**AMENDMENTS TO THE DRAWINGS**

### **REMARKS**

**FIG. 1**

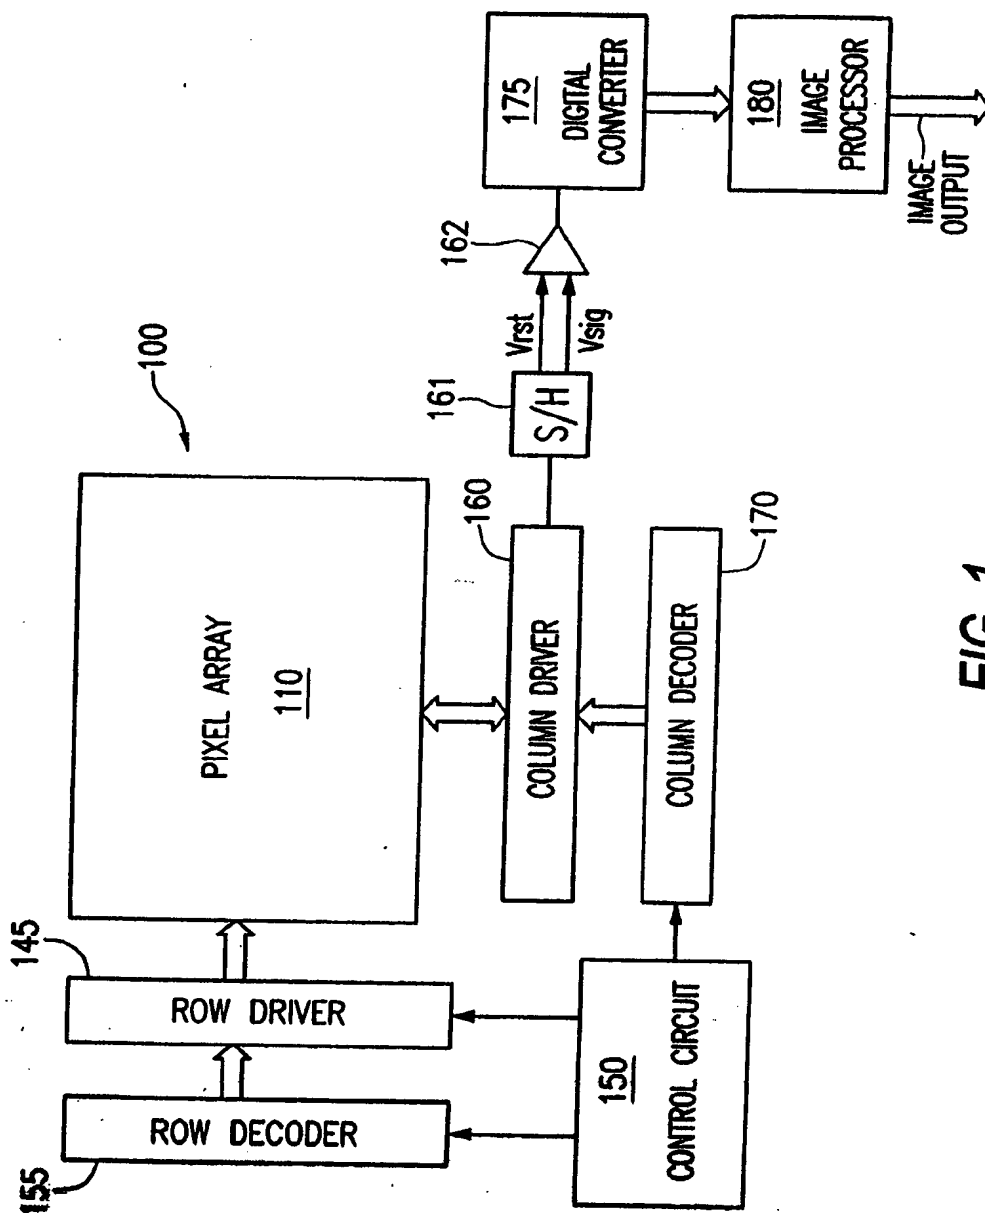
Figures 1 and 2 stand objected to as failing to comply with 37 CFR 1.84(p)(4) and (5). Figures 1 and 2 have been revised to indicate that they are prior art and Figure 2 has been revised to re-label the row select transistor with reference character "36." Applicant submits that the figures are in compliance with 37 CFR 1.84. In light of this revision, Applicant respectfully requests that the objection to the figures be withdrawn.
